RESPONSE TO REQUEST FOR ADDITIONAL INFORMATION

APR1400 Design Certification

Docket No. 52-046

RAI No.: 268-8308
SRP Section: SRP 19
Application Section: 19.1.
Date of RAI Issued: 10/02/2015

Figure 19.1-52 LPSD Level 1 Event Tree – Large LOCA (LLOCA) in POS 1

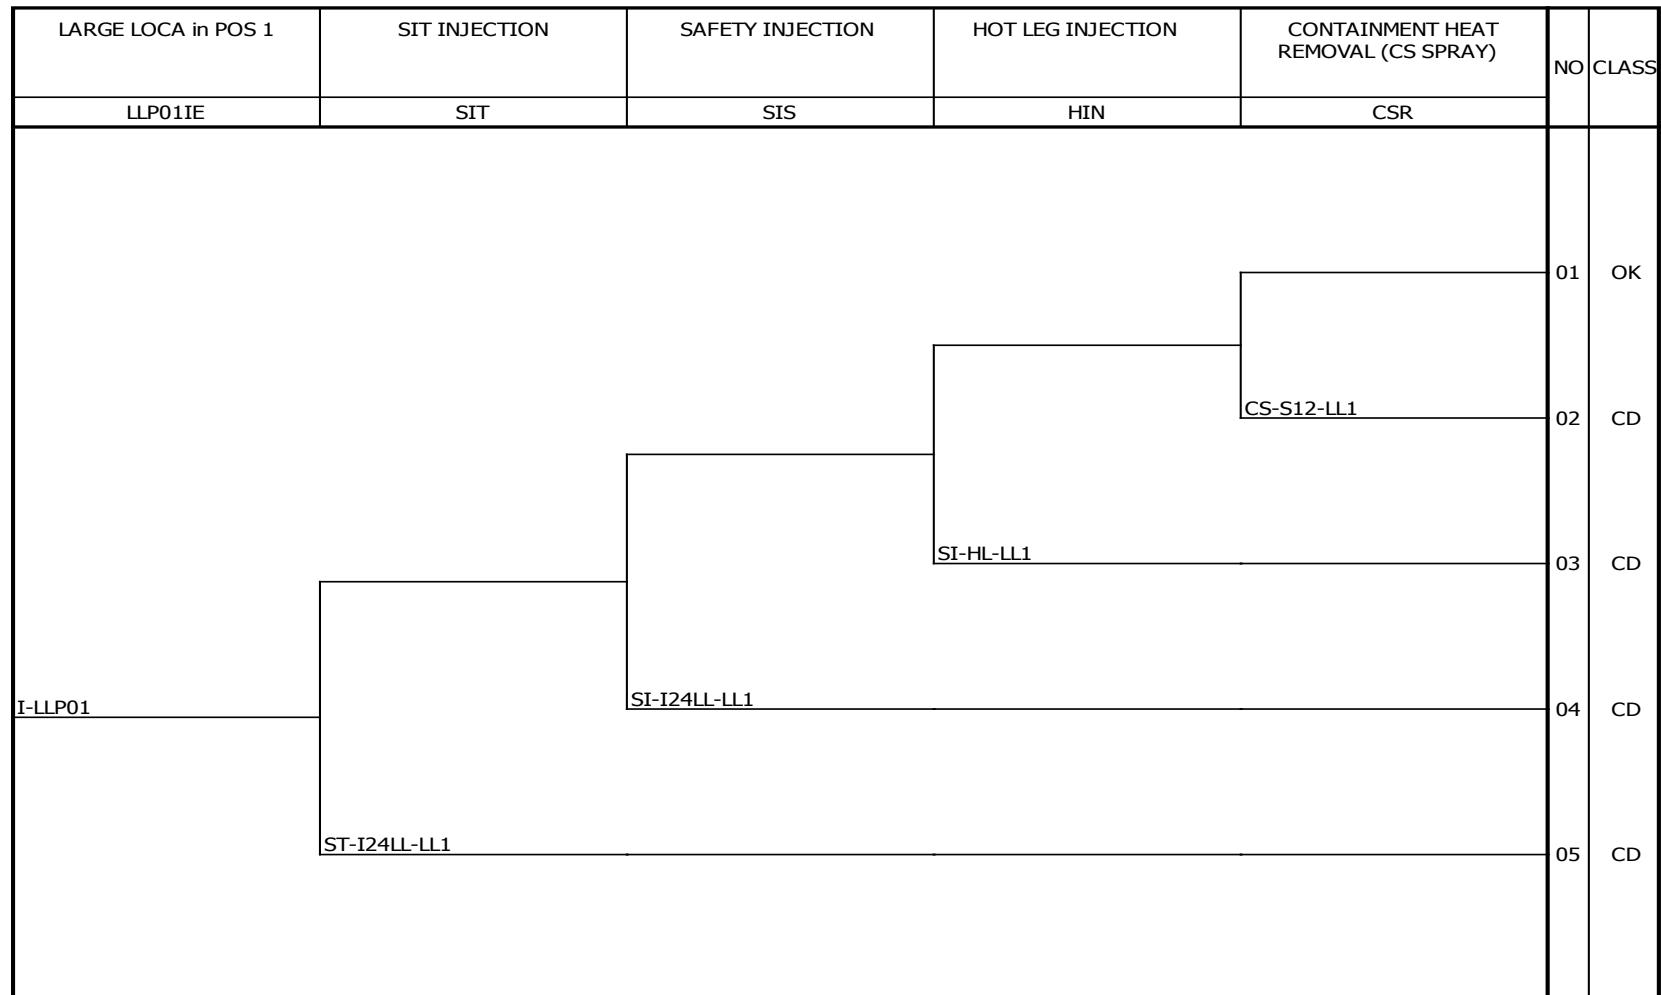
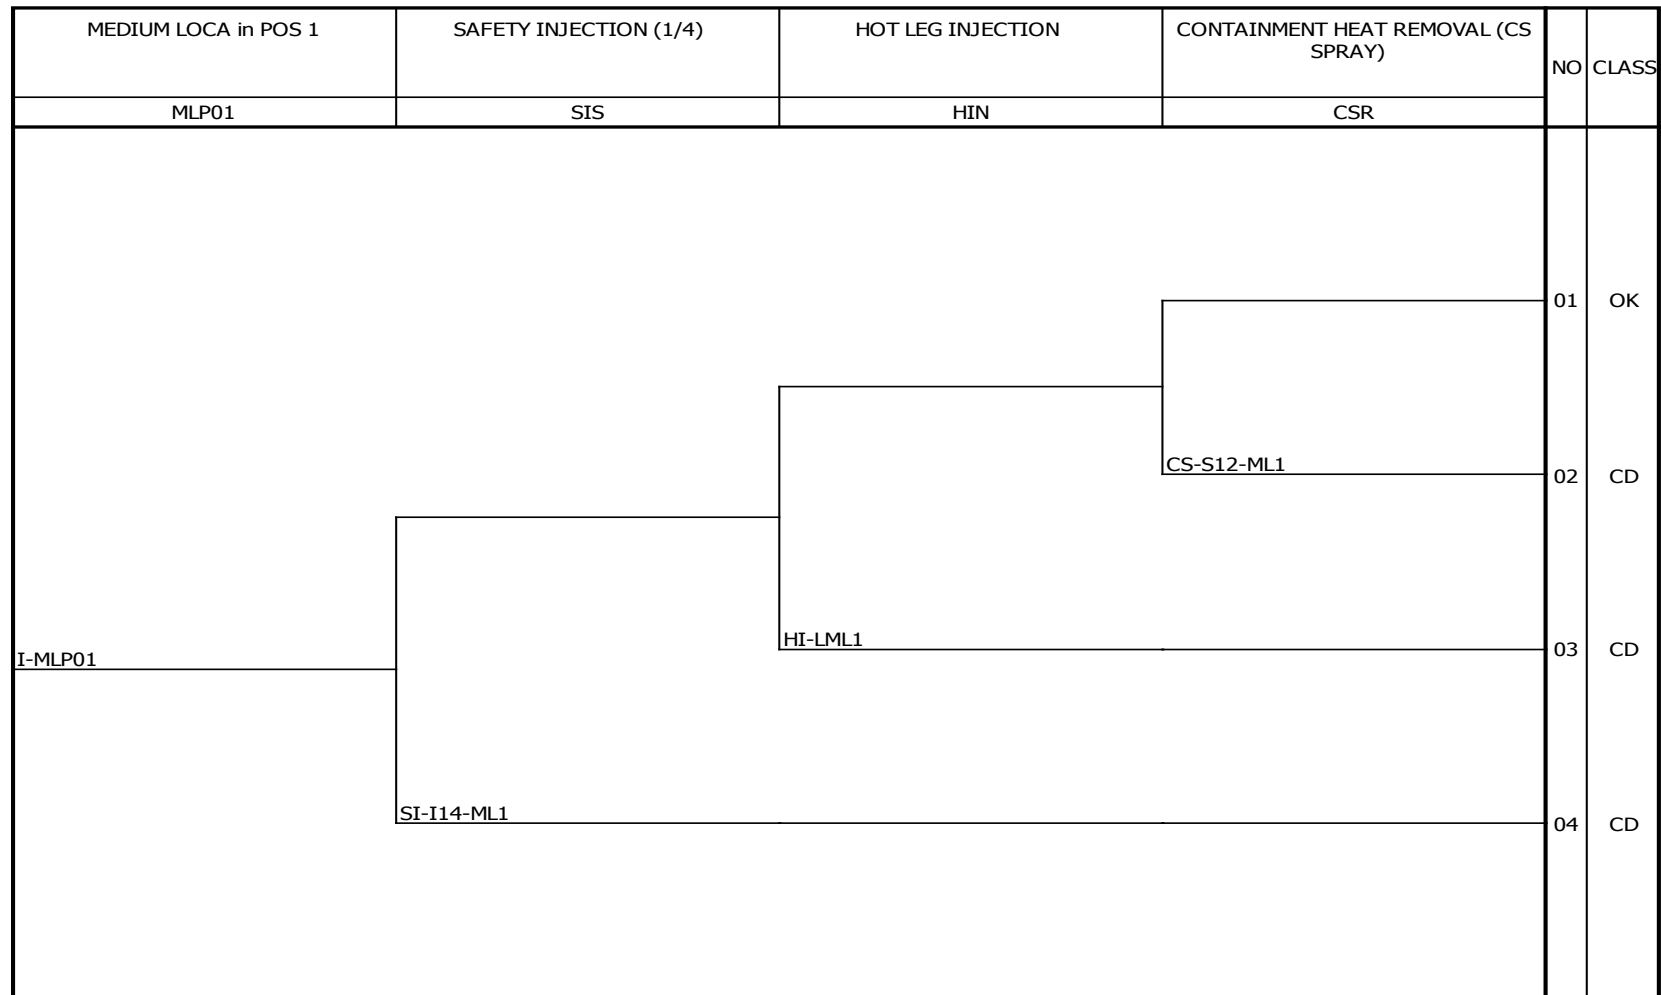
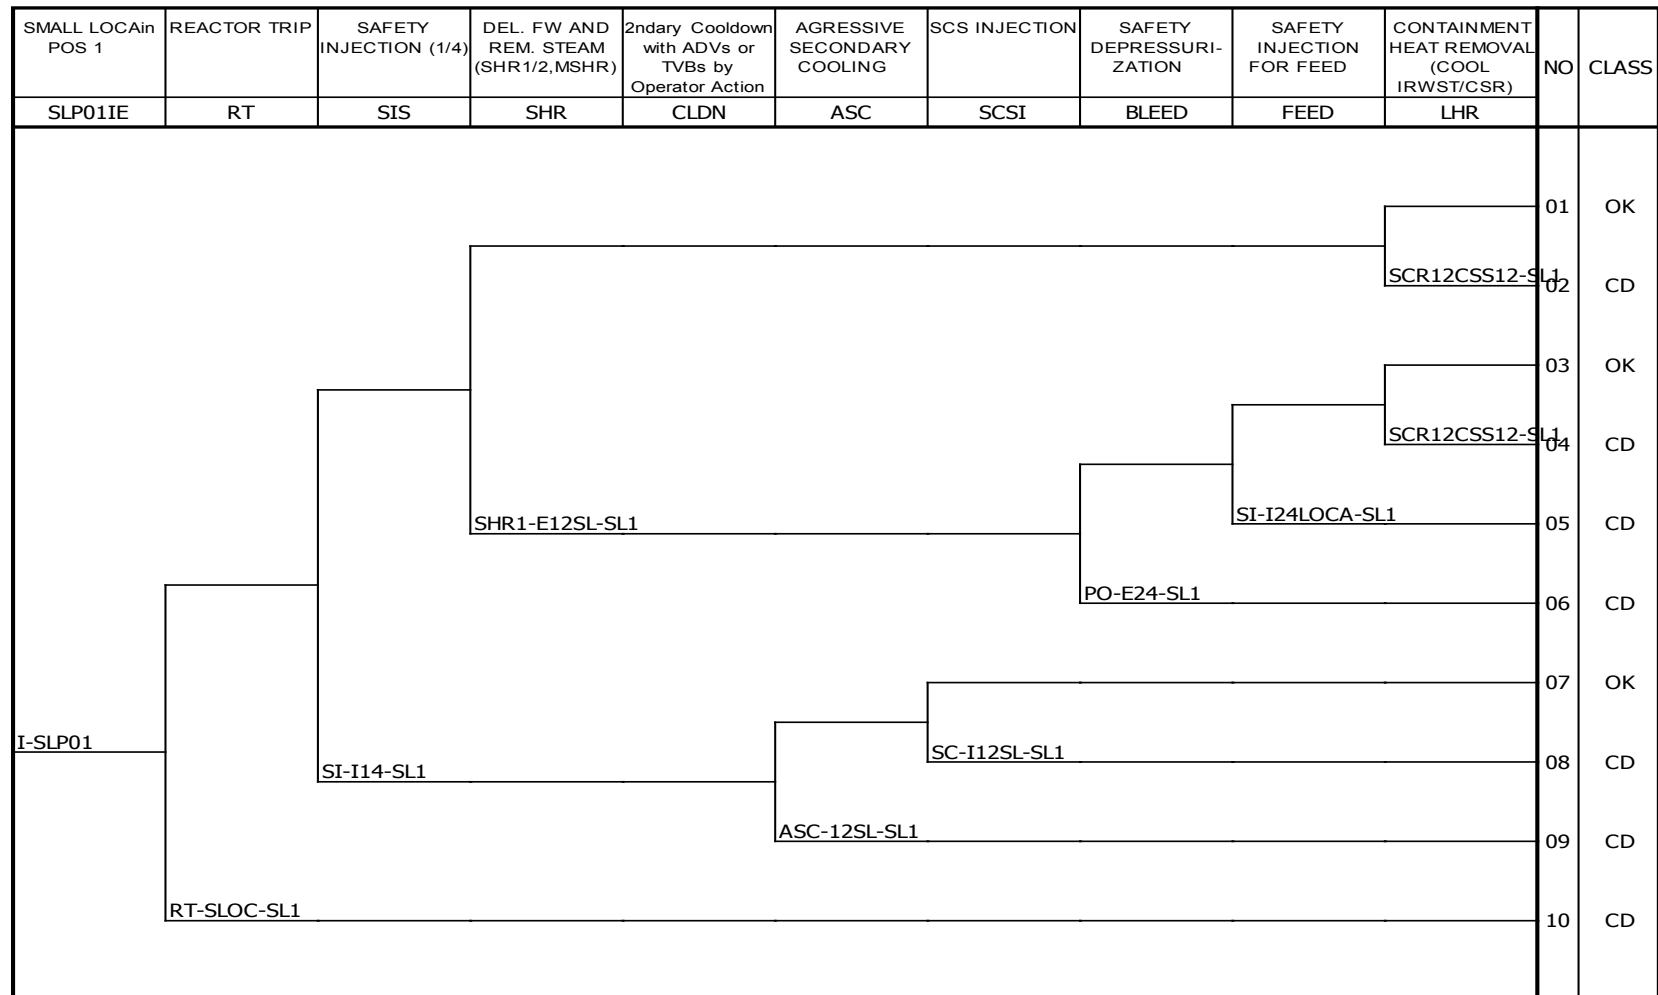
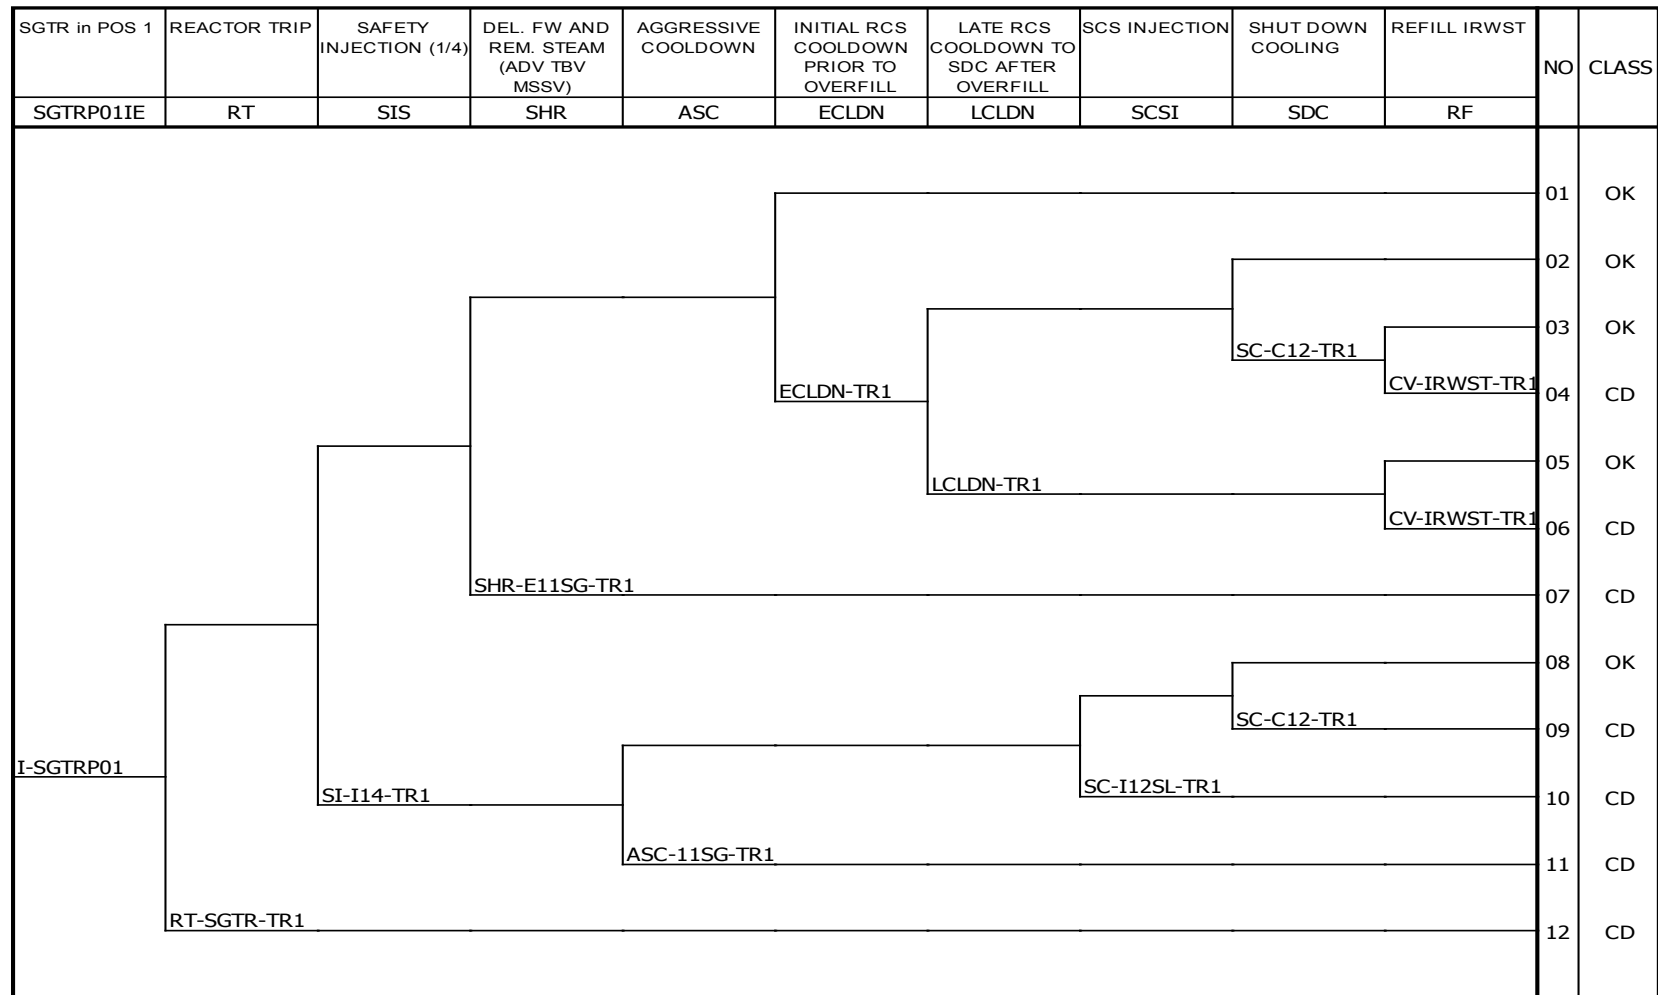
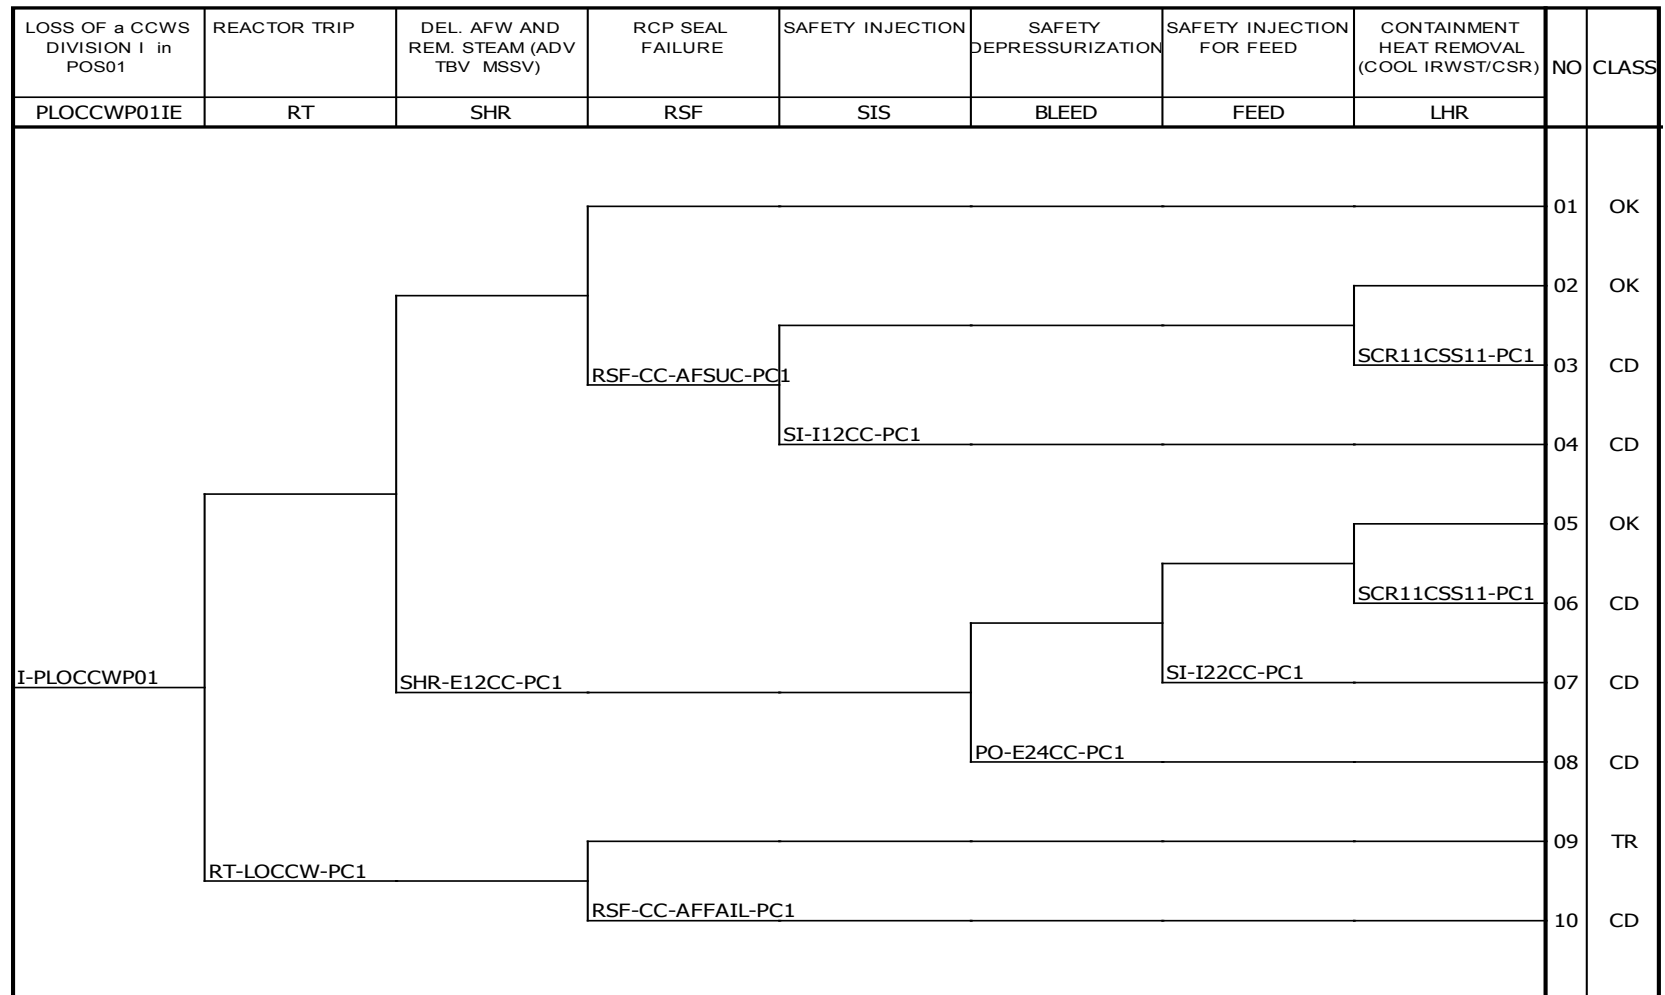
10 CFR 52.47(27) requires that a standard design certification applicant provide a description of the design specific PRA and the results. Design Control Document Section 19.1.6, appears to be missing event trees for all plant operational states other than plant operational state 5, which represents mid-loop conditions. However, the plant response to a loss of decay heat removal (DHR) is significantly different if the reactor coolant system (RCS) is intact versus an open RCS. To provide an example of how the different plant operational states were modeled in the probabilistic risk assessment (PRA), the staff is requesting that the applicant add the event trees for all plant operational states for the initiating event, loss of the operating train of the shutdown cooling (SDC) system. The staff considers these low power shutdown (LPSD) event trees part of the PRA results. These event trees will allow the reader to understand the varying plant response to a shutdown initiating event given the different plant operational states.

The twelve (12) event trees for POS 5 are included as Figures 19.1-52 through 19.1-63 in DCD 19.1. In response to this RAI, the low power and shutdown (LPSD) event trees for all plant operational states will be added to the DCD. The supporting discussion will also be revised.

The POS 5 LPSD event trees in Figures 19.1-52 through 19.1-63 will be supplemented to present the event trees for all plant operating states in Figures 19.1-52 through 19.1-208 and also figure for LPSD Containment Event Tree will be changed to Figure 19.1-209 as shown in the Attachment 1

~~The LPSD event trees for POS 5, which occurs during mid-loop operation, are contained in Figure 19.1-52 through Figure 19.1-63.~~

The LPSD event trees for all plant operational states (POSs) are presented in Figures 19.1-52 through 19.1-208. The LPSD containment event tree is presented in Figure 19.1-209.
